## PLANNING AND ZONING CASE CHECKLIST City of Rockwall Planning and Zoning Department

### RIVERROCK TRAILS, PHASE 1A

08/05/2020: Revision 1 Comments - P2020-029; Preliminary Plat for RiverRock Trails, Phase 1A Addition - ETJ Please address the following comments (M= Mandatory Comments; I = Informational Comments)

ERROCK TRAILS, PHASE 1A - PRELIN

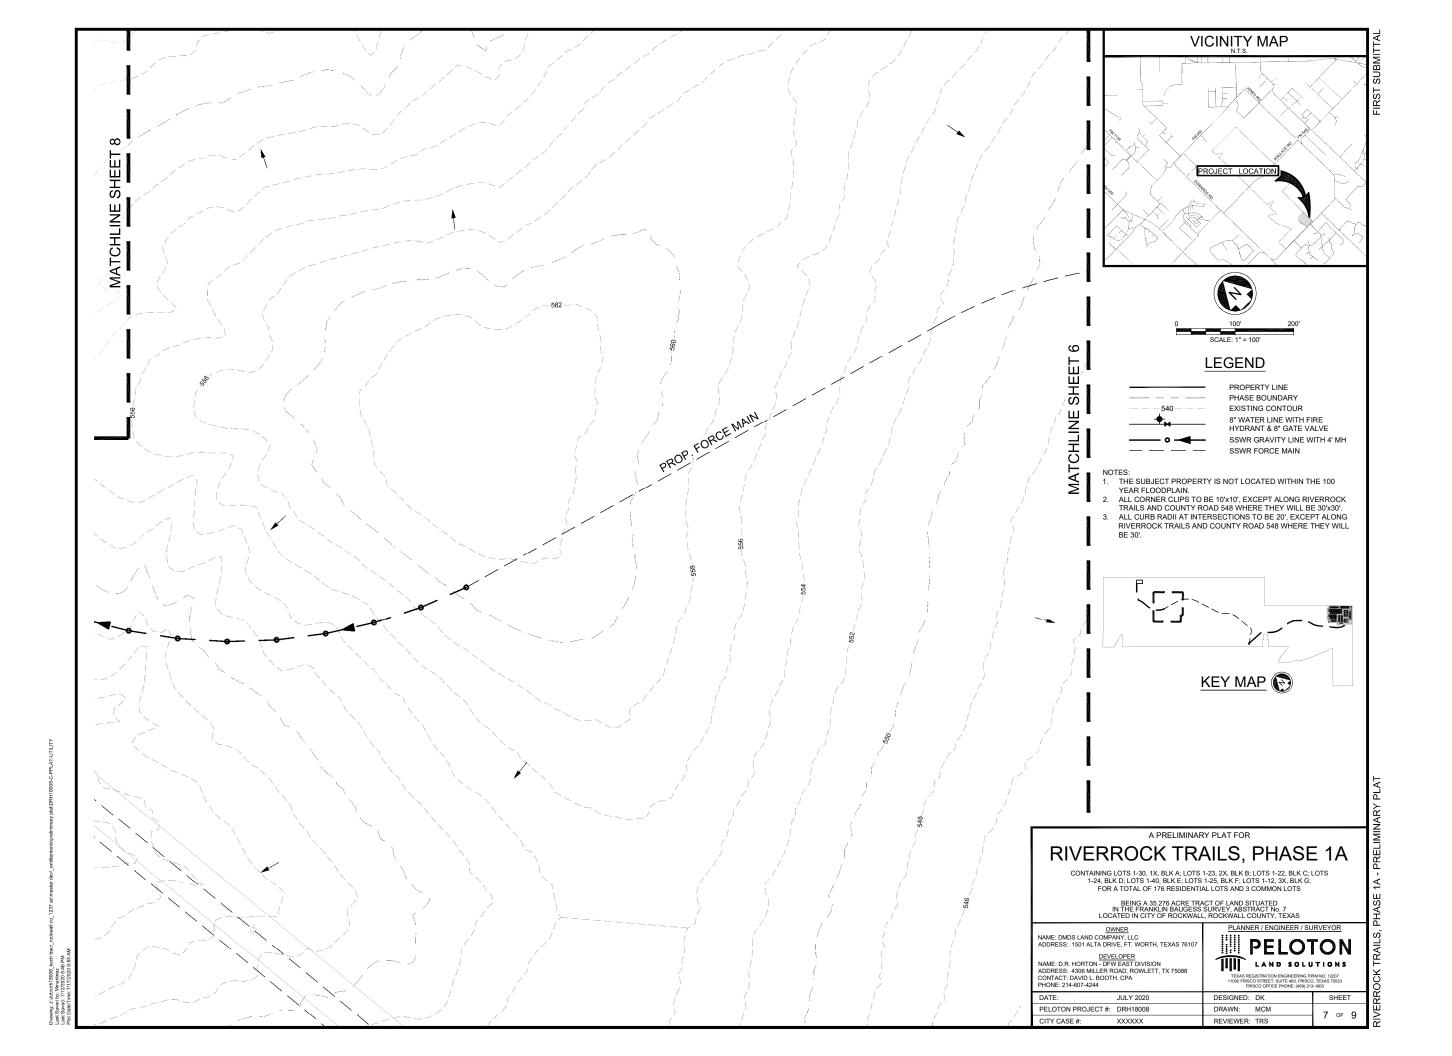
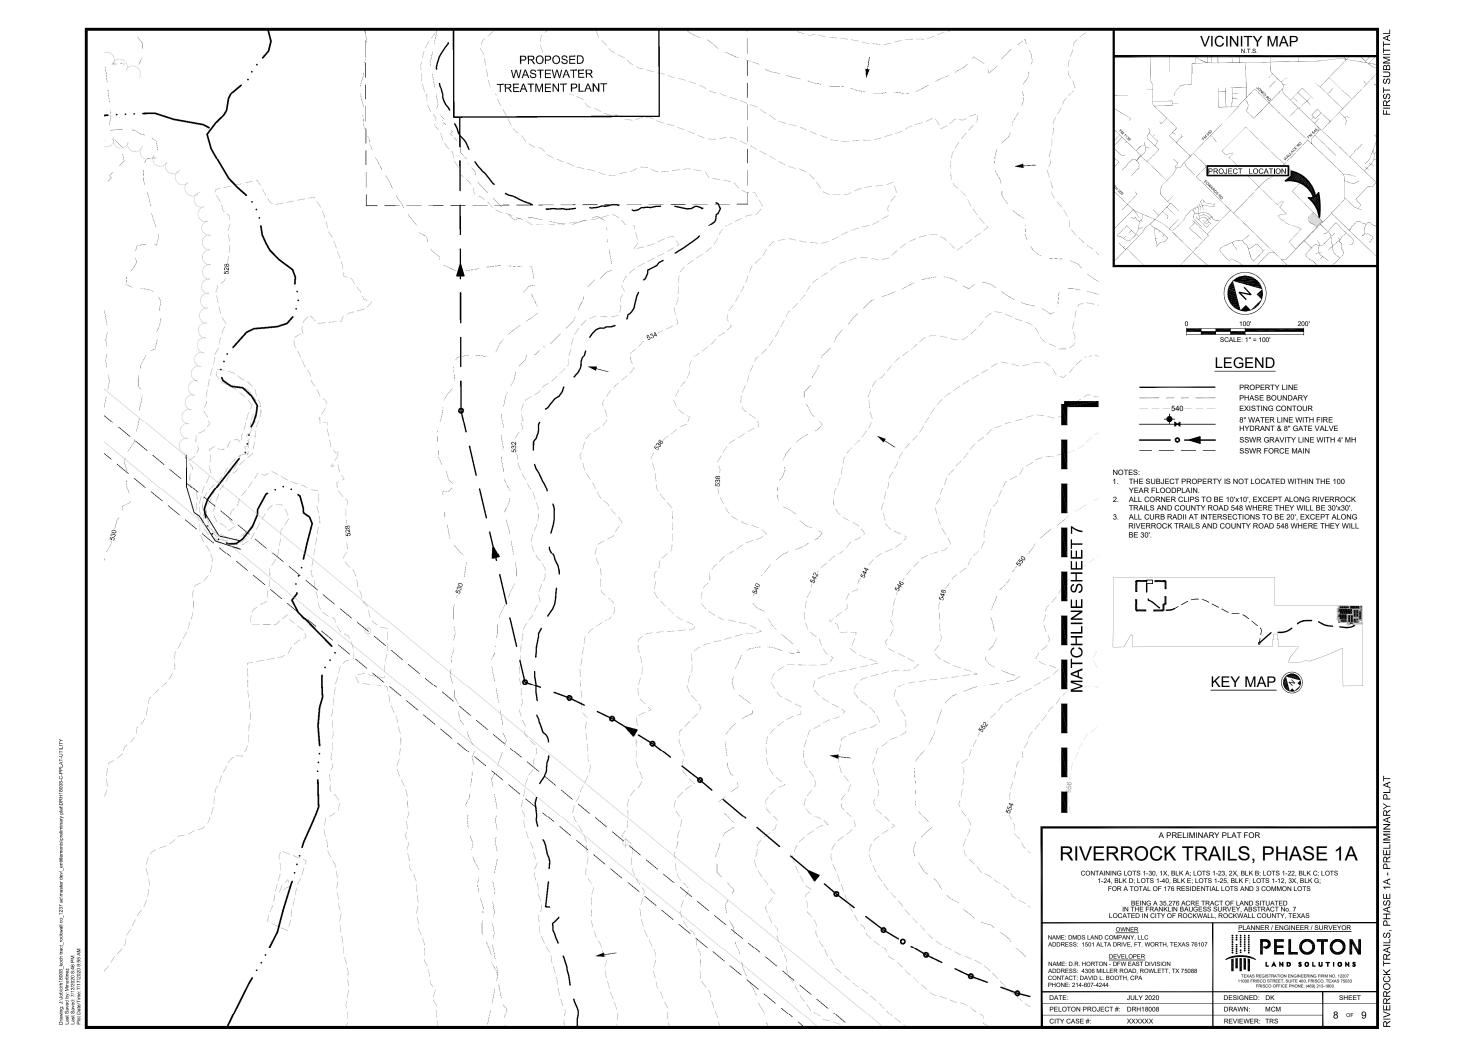
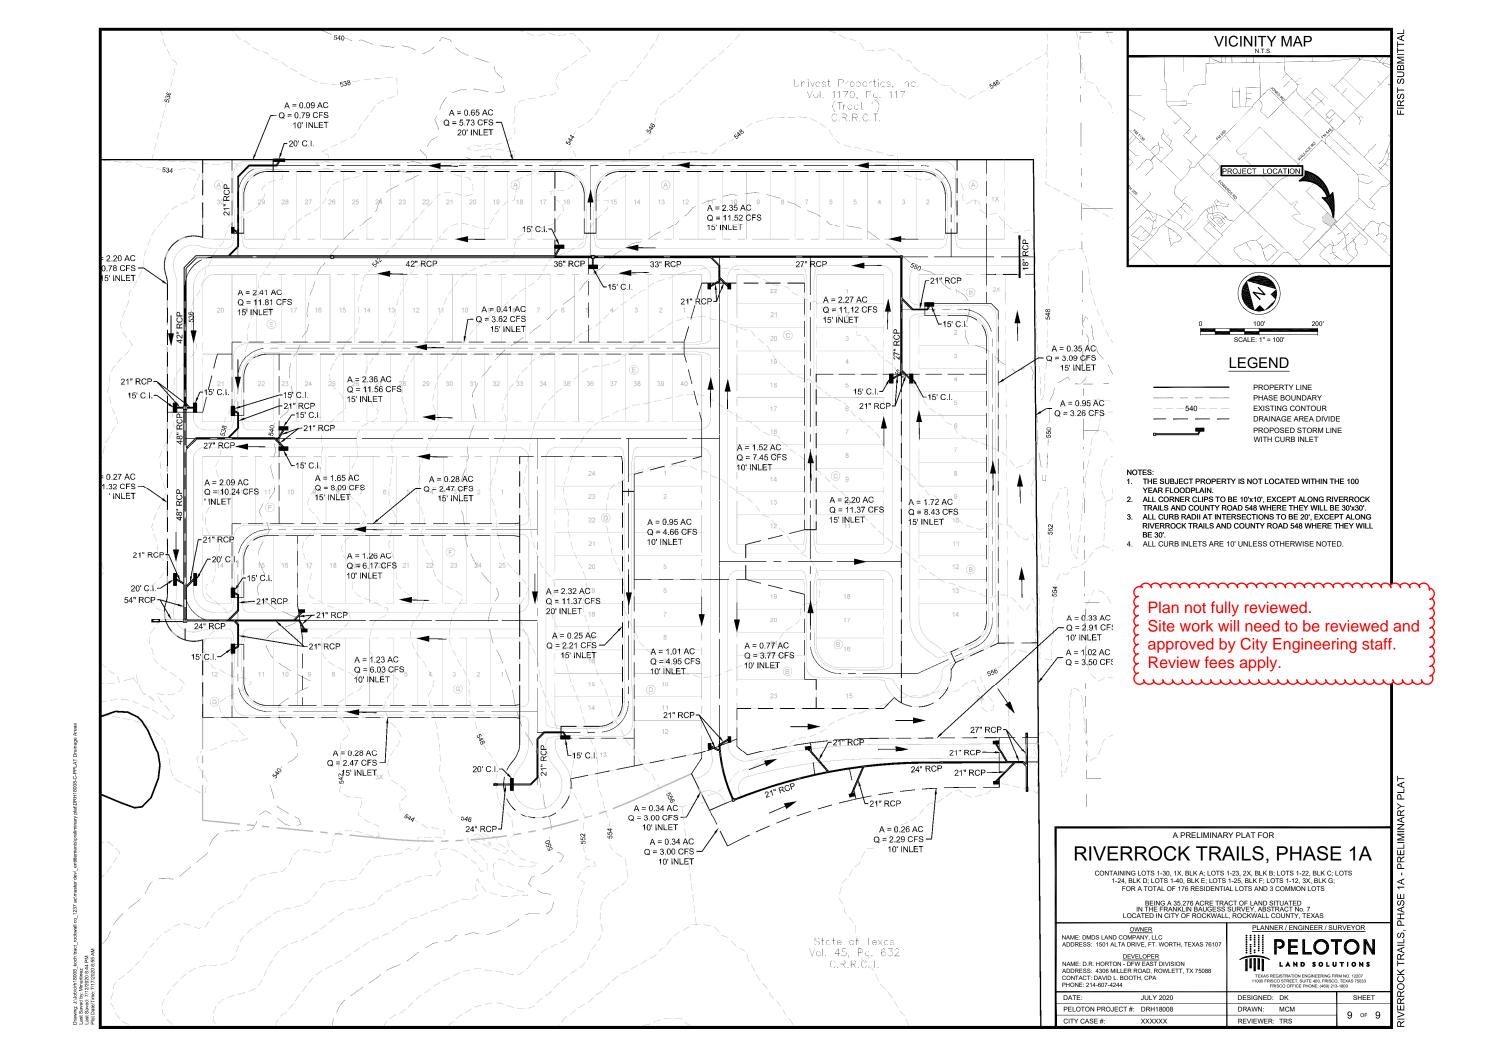
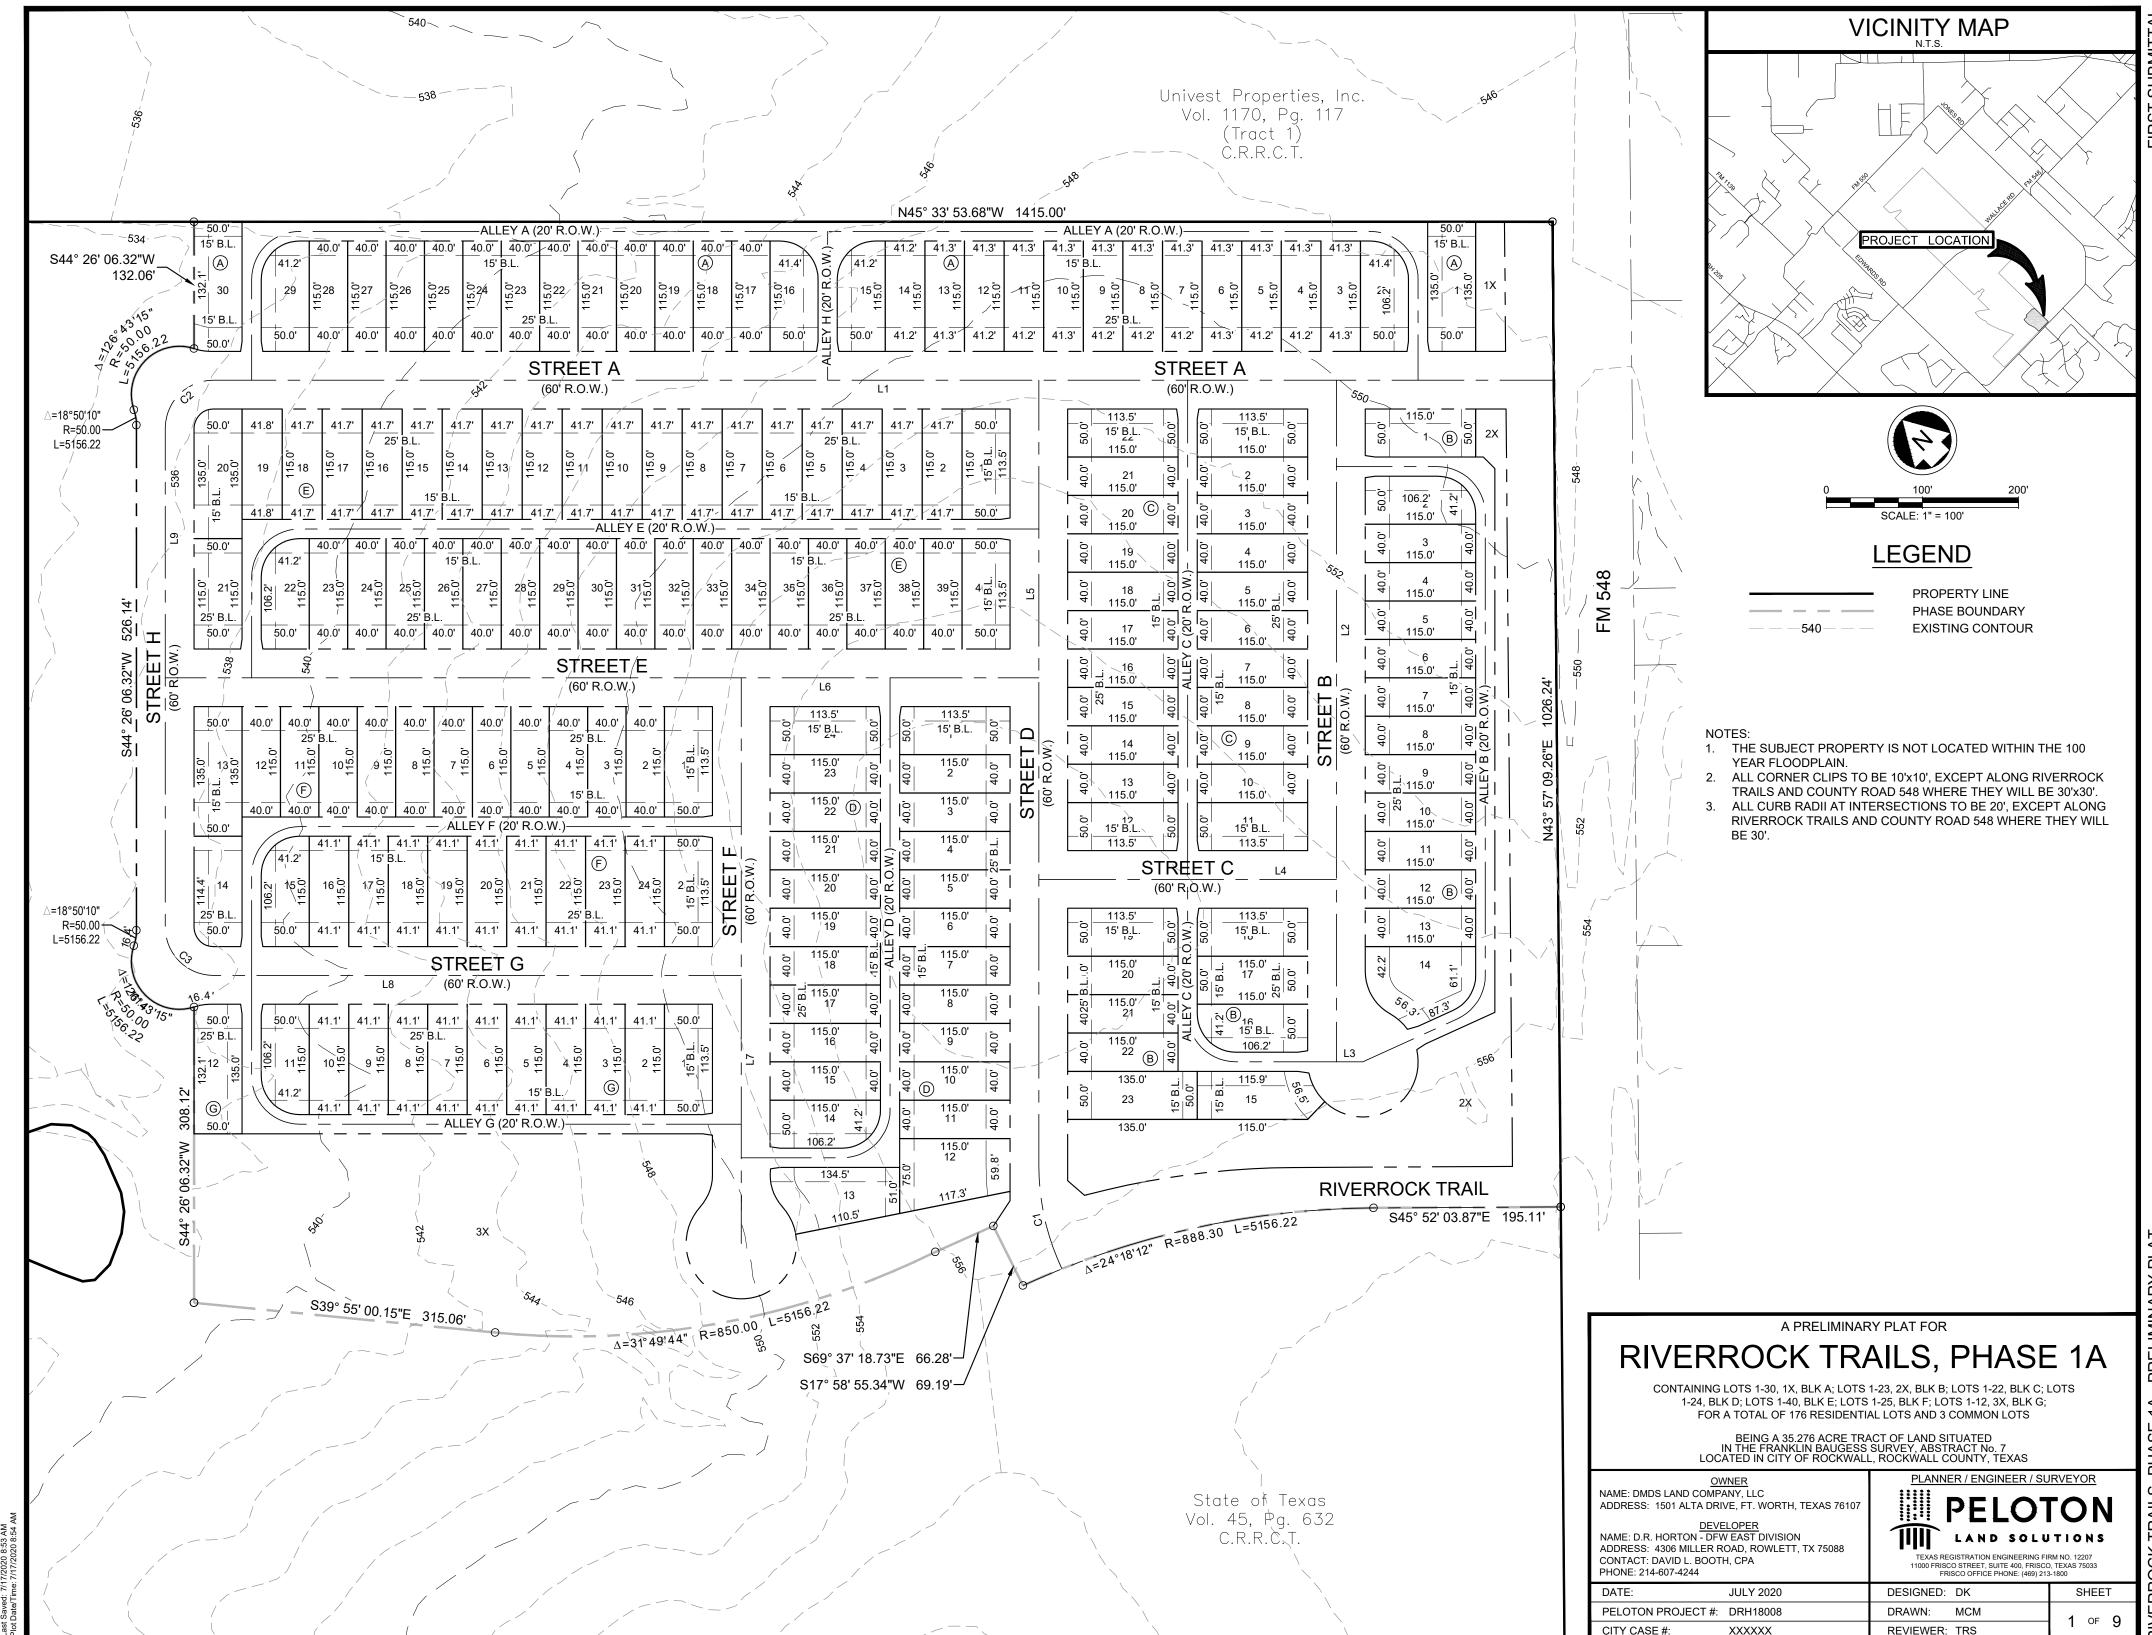
- M.6 Correct Title Block by removing "City of Rockwall" where indicated on last line that reads "located in City of Rockwall..." This should read "located in Rockwall County, Texas" (Chapter 38, Subdivision Regulations, Municipal Code of Ordinances)

- M.12 Identify the dimensions, names and description of all open spaces, both existing and proposed. Provide labels for the three (3) common areas to indicate "Open Space." (Section 38-8(b)(6)e, Plat Contents, Municipal Code of Ordinances)

- M.14 Indicate the boundary lines, dimensions and descriptions, of spaces to be dedicated for public use of the inhabitants of the development. Provide labels for areas where applicable. (Section 38-8(b)(6)e, Plat Contents, Municipal Code of Ordinances)

- M Corner clips to be 20'x20', alley clips are 10'x10'. Show these clips.
- M Rockwall County Thoroughfare Plan shows FM 548 to be a Principle Arterial with 120' ROW. verify proper ROW width.

- I Must include a 20' utility easement along FM 548 and Street A per the Water Master Plan.
- I Must have 8" water line looped throughout the site.
- I Minimum 8" sanitary sewer lines.

- I Truck sanitary sewer line must be 12" per the Master Sewer Plan.
- I TxDOT permit required for driveways on FM 548.
- I Retaining walls 6" and over must be rock or stone faced.
